ADMINISTRATIVE APPROVALS

May 20, 2020

111 (145) Maplewood Avenue

Interdepartmental Consistency Report - Response

1. MECHANICAL PENTHOUSE SCREEN
 111 MAPLEWOOD AVE
 PORTSMOUTH, NH

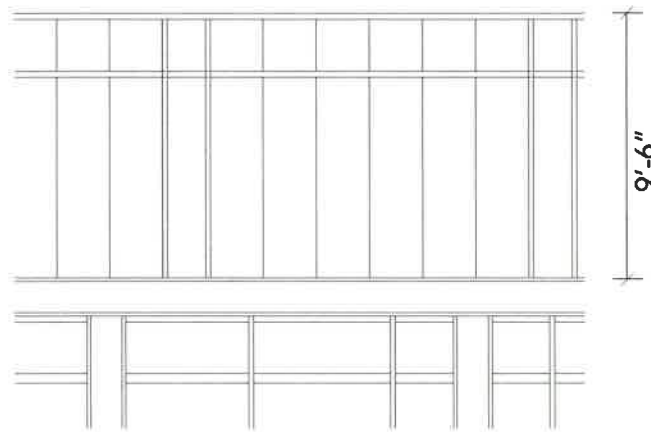
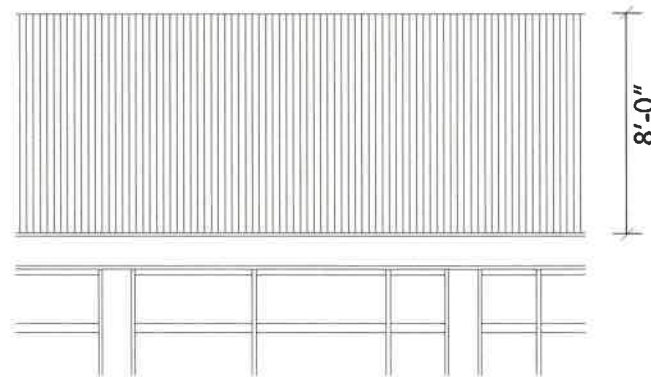
1. Mechanical Penthouse Screen
2. Maplewood Ave. Trellis
3. Raynes Ave. Curtain Wall Fin System
3a. Bay projection clarified, page 27
4. Reduced Granite Base
- 5a. Terracotta Arches Changed to wood
5a1. 4" wood siding (Thermory)
5b. Wood reveals removed
6. Canopy on Raynes and Vaughn Removed
- 7a. Additional Exterior Door Added
- 7b. Exterior Door Removed
8. 4th Floor Enlarged
8a. Curb line note corrected, page 21
9. Garage Vent Louver on East Side Added
10. Louvers changed to Spandrel on Raynes

19. Band projects above roof line due to sloping roof for drainage

18. Cornice height clarified, 3'-1" tall

EAST ELEVATION - Entry Passage
 111 MAPLEWOOD AVE
 PORTSMOUTH, NH

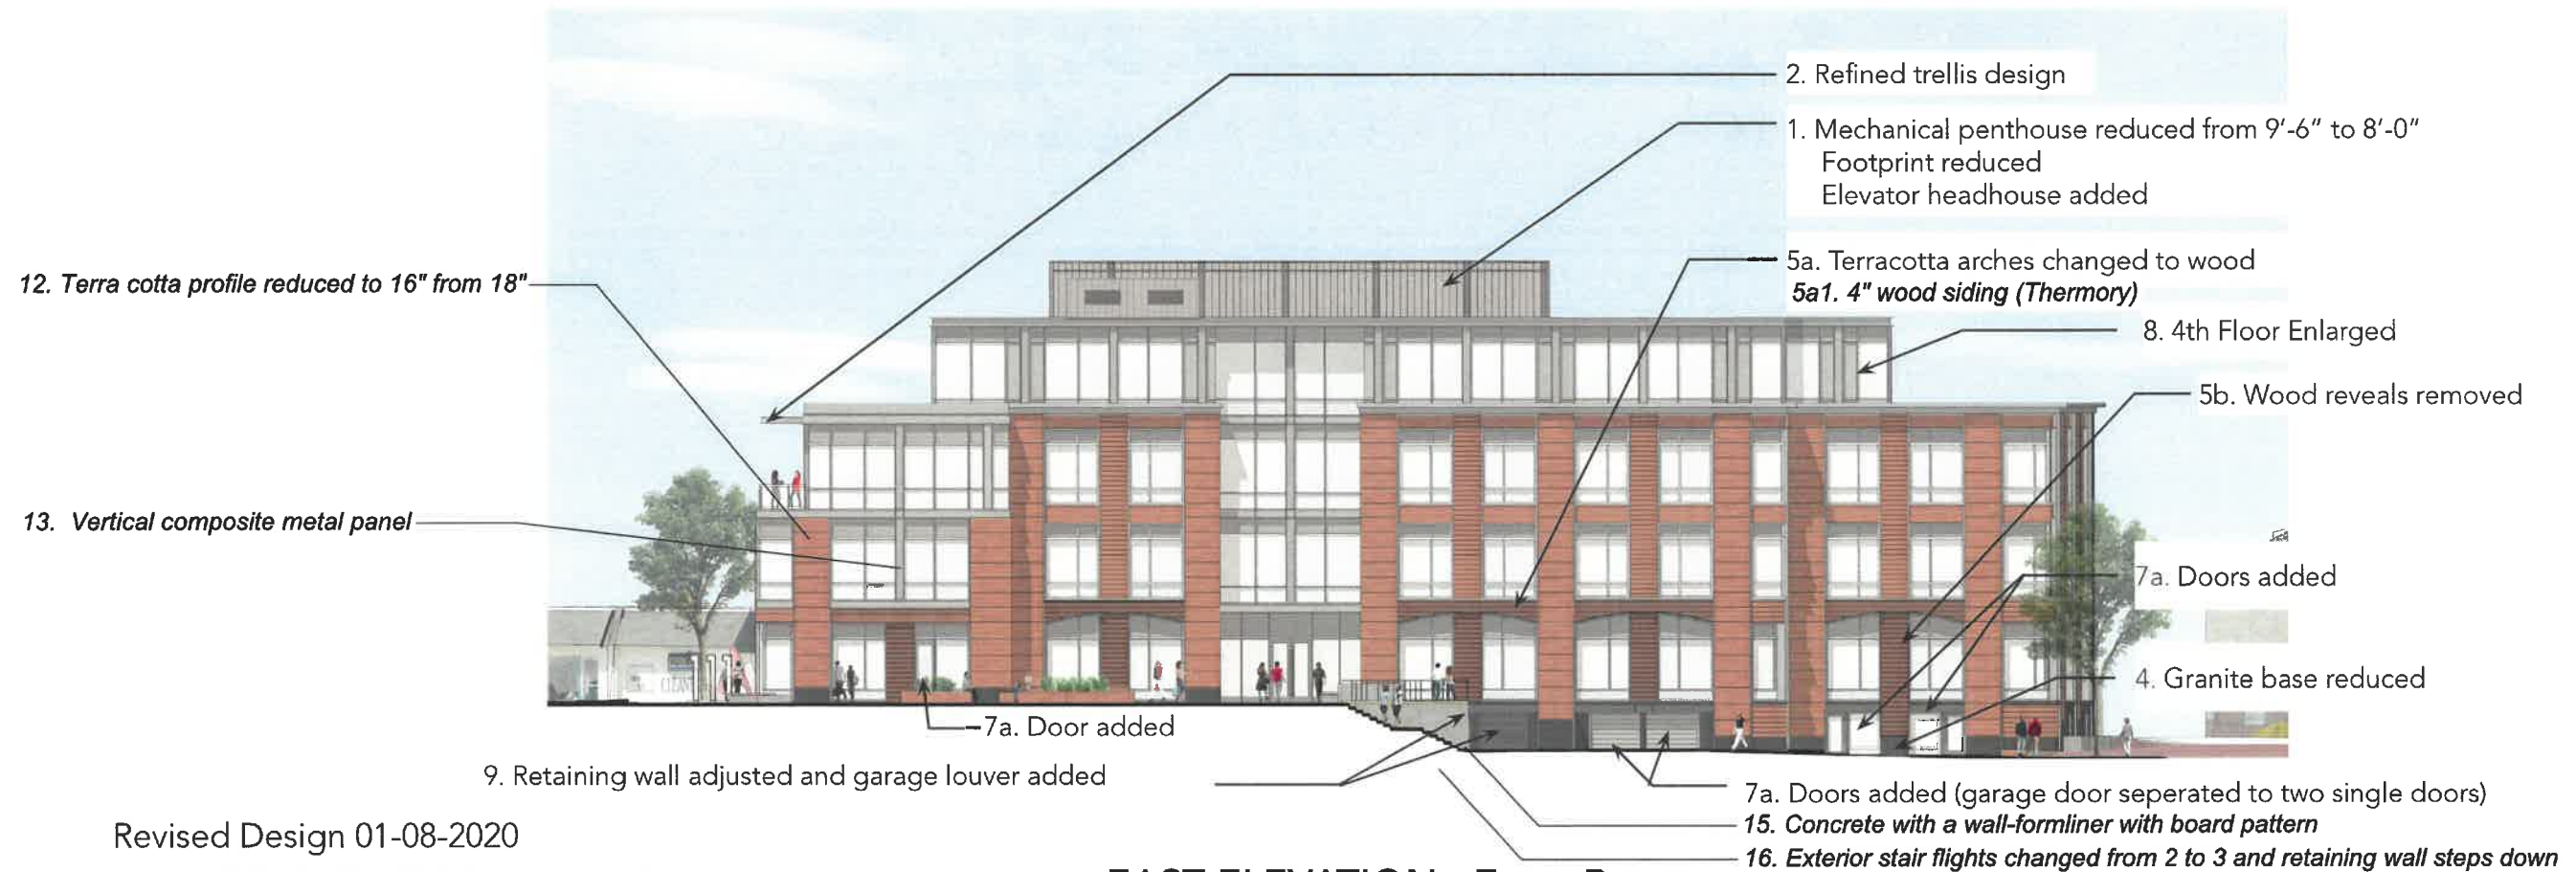
3. The change from 8" Terra Cotta profile (shown on pg. 10 of the May 3, 2019 HDC approval) to 4" THERMOARY profile was not explicitly called out in any corresponding HDC approval request (all elevations, where applicable).

Response: Terra cotta to Thermory wood change was noted (see note 5a) on pages 6, 7, 10, 12, 14 & 15 of 01/08/2020 HDC Submission.

5a1. 4" wood siding (Thermory)

SETBACKS + BUILDING HEIGHTS
 111 MAPLEWOOD AVE
 PORTSMOUTH, NH

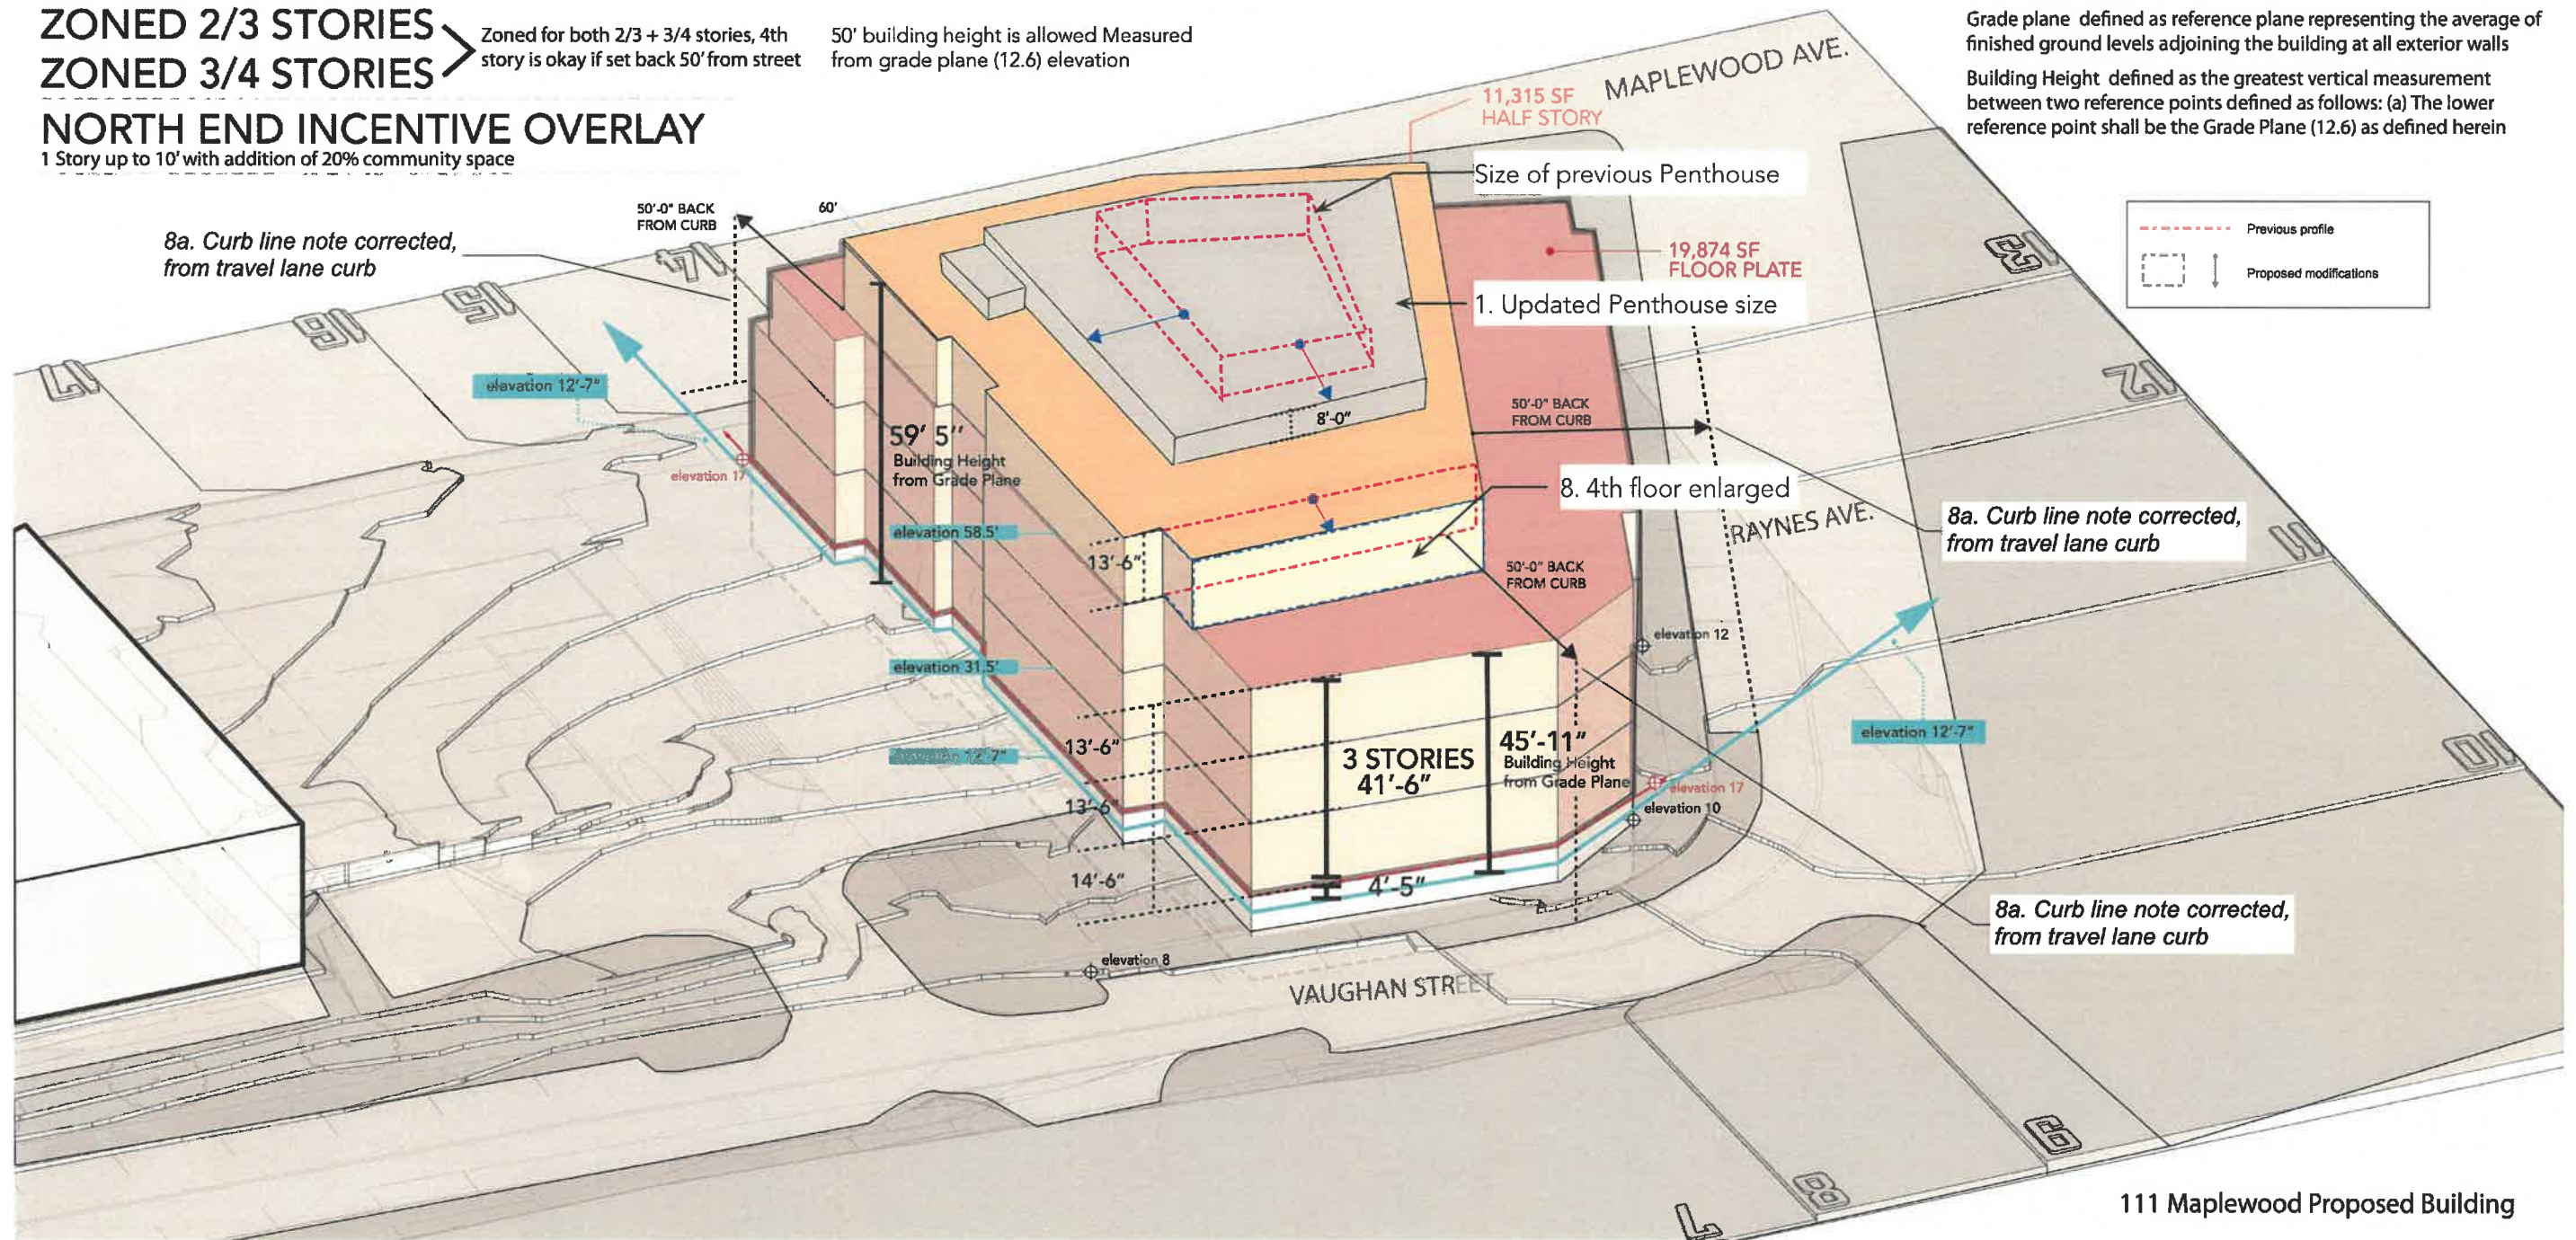
- B. "Setback Key Plan – Fourth Floor" indicates the fourth floor structure will be setback 50' from the edge of parking spaces on Raynes, Maplewood, and Vaughan R.O.Ws. Pg. 21 of the January 8, 2020 HDC approval indicates the fourth floor structure is setback 50' from edge of curb on the respective streets.

Response: The 50' setbacks shown on sheet LS.04 measure from the travel lane curb line. We understand from the Owner's Attorney, based on a letter sent to Juliet Walker dated February 14, 2019 (Appendix A), that the travel lane curb line is to be used for this setback, not the parking curb line. Pg. 21 of the January 8, 2020 HDC approval indicates "back from curb", but is unclear which curb line is referenced. Approved civil plans are based on the travel lane curb line for these setbacks.

Zoned for both 2/3 + 3/4 stories, 4th story is okay if set back 50' from street

1 HDC BUILDING ELEVATION - ENTRY PASSAGE (EAST)
3/32" = 1'-0"

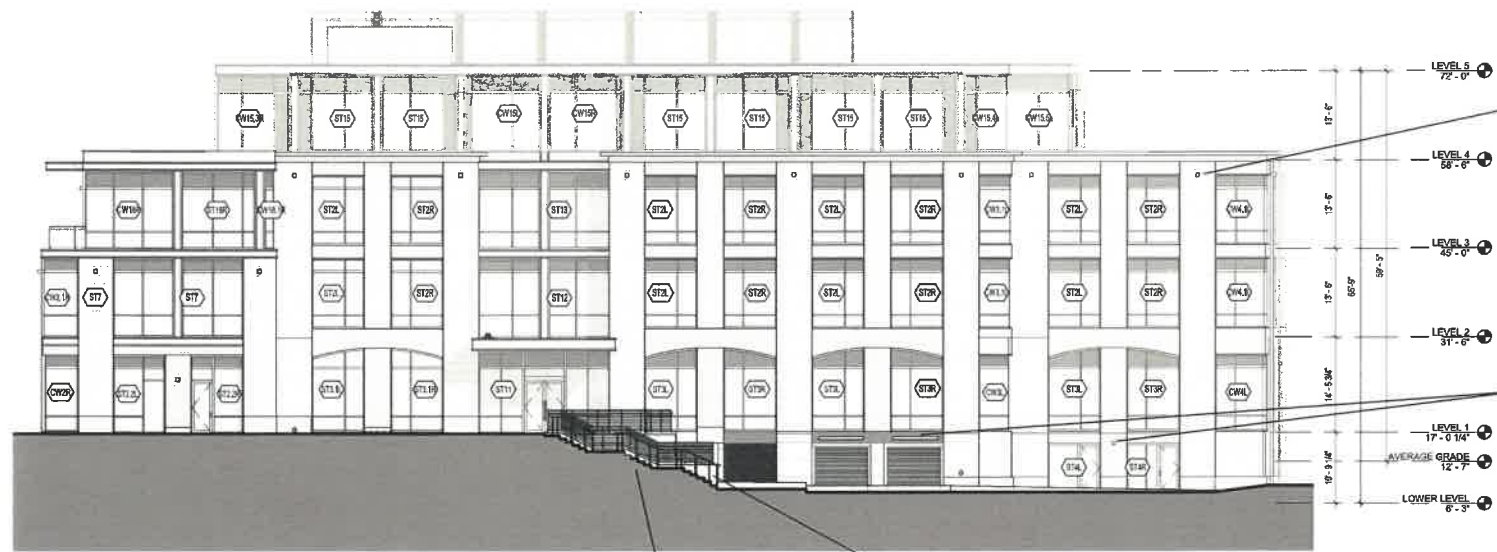
8. Wall material along staircase has changed from concrete shown on the corresponding HDC approvals to a slatted profile.
Response: Wall material along staircase is not noted on the HDC sets. This was clarified in the Civil and Landscaping Administrative Approval Set submitted to the City on February 14th, 2020 and approved on March 19, 2020 (Appendix B). Wall is concrete with a wall-formliner with board pattern. This reflects the wood siding on the building. See sheet L-506. Note that a mock-up will be provided on site.
Note 15. The January 8, 2020 HDC Submittal will be updated.

15. Concrete with a wall-formliner with board pattern

16. Exterior stair flights changed from 2 to 3 and retaining wall steps down

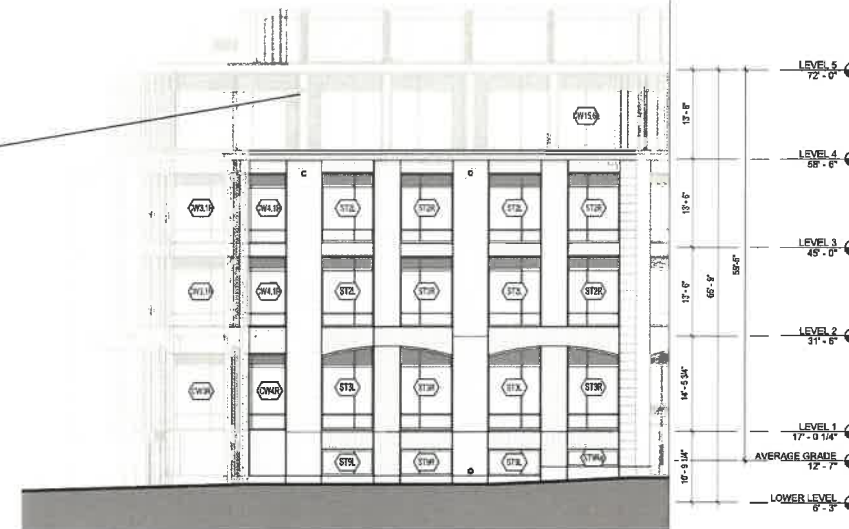
9. The staircase running along this elevation has increased to 3 flights from the 2 flights shown on corresponding HDC approvals.
Response: Stair flights are shown on page 22 of the January 08, 2020 HDC drawings. This was also clarified in the Civil and Landscaping Administrative Approval Set submitted to the City on February 14th, 2020 and approved on March 19, 2020 (Appendix B).

10. This elevation has been mislabeled as Raynes Ave. In addition, the recessed area with retaining wall shown here is not on any corresponding HDC approvals.

Response: Drawing 3 and 4 on sheet A3.00 were mislabeled. This faces the entry passage side. This area is shown on page 22 of the January 08, 2020 HDC drawings. This was also clarified in the Civil and Landscaping Administrative Approval Set submitted to the City on February 14th, 2020 and approved on March 19, 2020 (Appendix B). Retaining wall steps down.

2 HDC BUILDING ELEVATION - MAPLEWOOD AVENUE (SOUTH)
3/32" = 1'-0"

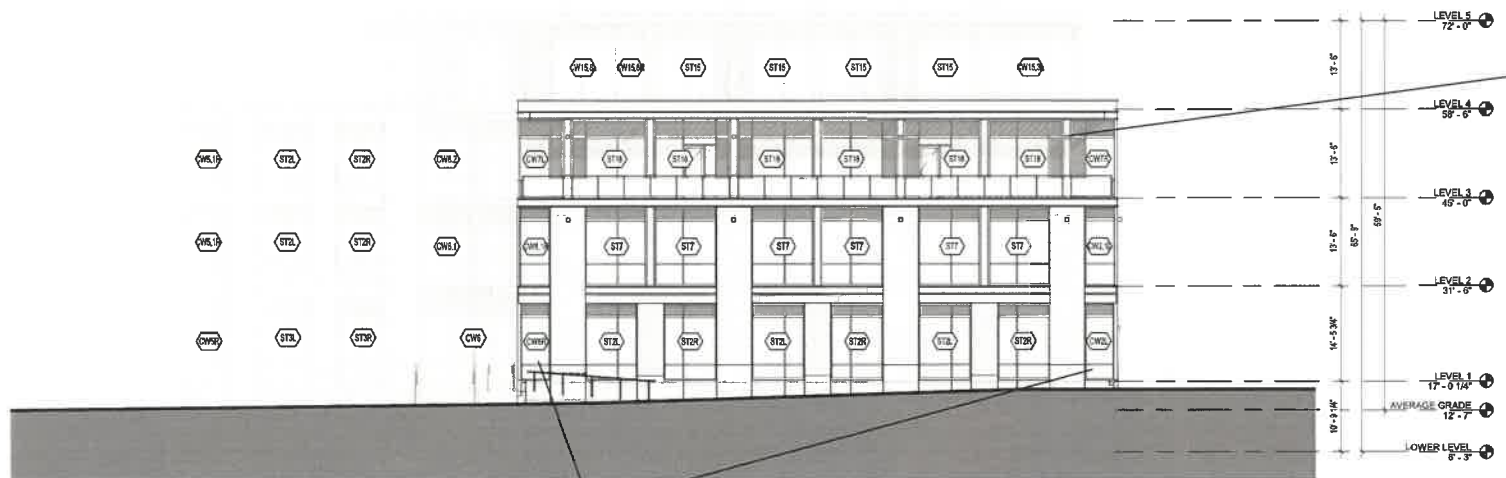
15. Ground and second story end windows below the Maplewood Ave. balcony are larger than what is shown on corresponding HDC documents.

Response: There were constructability issues with size of glass, window frame sizes, etc. on the 1st floor at these corners facing Maplewood Ave (too narrow). This was corrected and the glazed corners are more in line with the other glazed corner sizes in the project. Page 22 reflects this correction on the January 8, 2020 HDC approval.

17. Glazed corners adjusted to match all other window corners

20. Cornice detail modified, 4" reduced from 11"

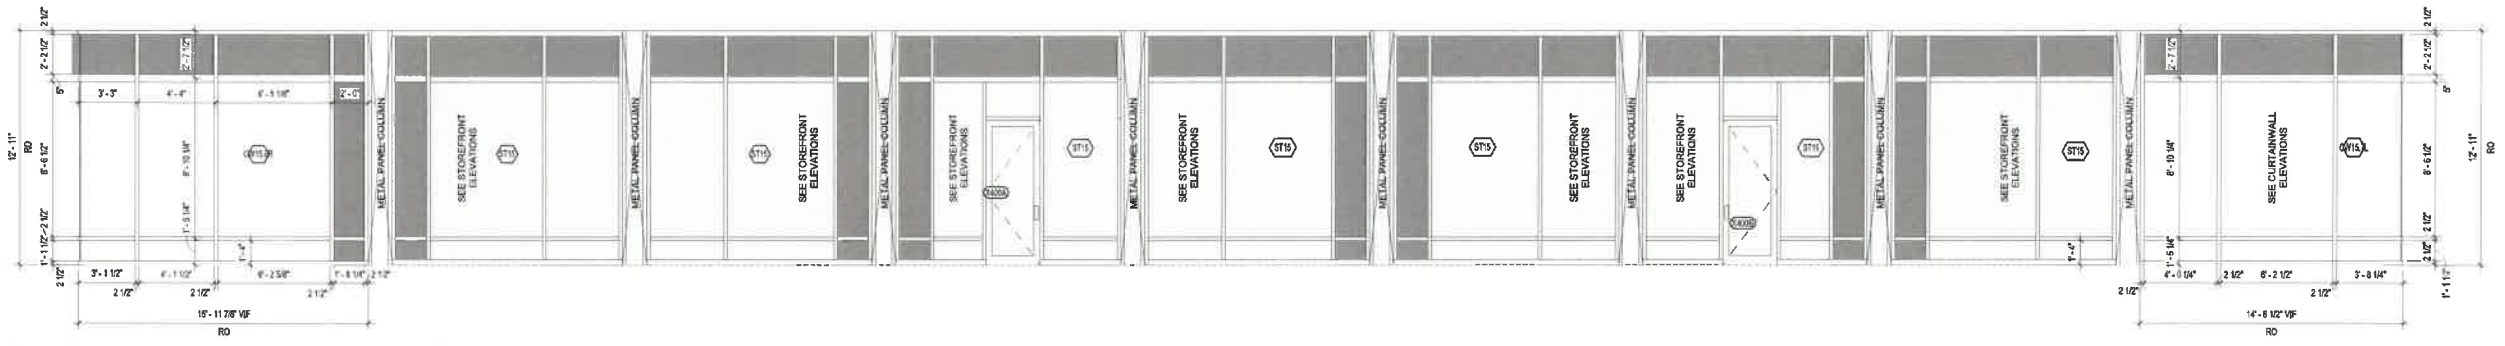
26. Typical cornice detail omits 11" x 11" detail shown on pg. 20 of the May 3, 2019 HDC approval.

Response: Typical cornice maintains 11" height. 11" depth was changed to meet constructability of head/jamb/sill returns at terra cotta and cornice intersections along roof edge.

5 CW PLAN - CW1
1/4" = 1'-0"

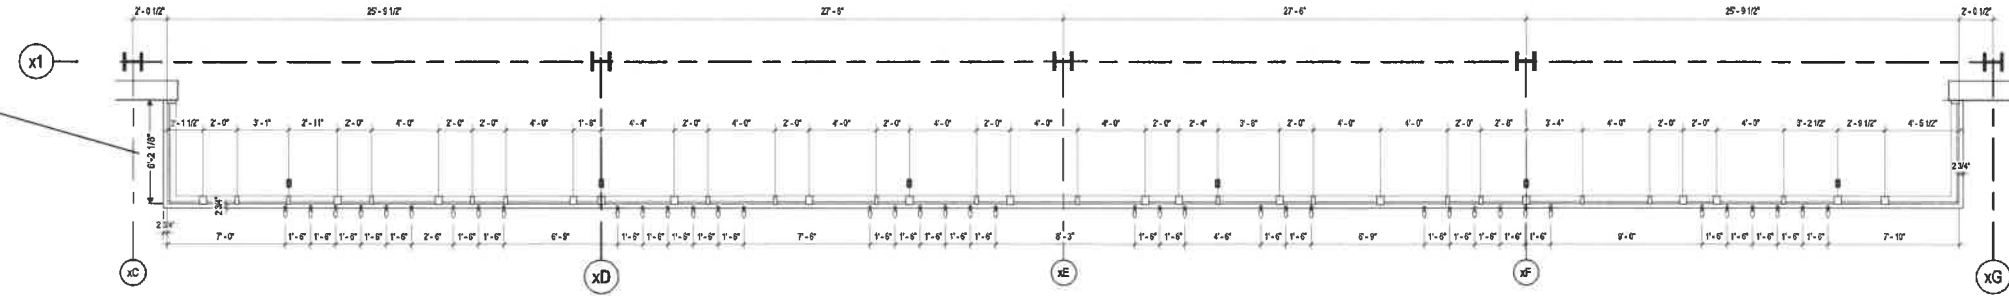
1. The cantilevered 2nd floor bump out (i.e. running parallel to Rayne's Ave) is shown here as 8'-5" in depth. Corresponding details on pg. 12 of the May 3, 2019 HDC approval does not reflect this amount of depth. Further, pg. 27 of the January 08, 2020 HDC approval appears to indicate the cantilevered bump out does not project more than 8' from the wall plane.

Response: 8'-5" +/- dimension (from Gridline 'x1') on Sheet A1.02 matches 8'-6" dimension on detail 5 on page 27 of 01/08/2020 HDC submission. Dimension from face of terra cotta wall to exterior face of glazing/mullions = 6'-2" +/-.

3a. Bay projection clarified
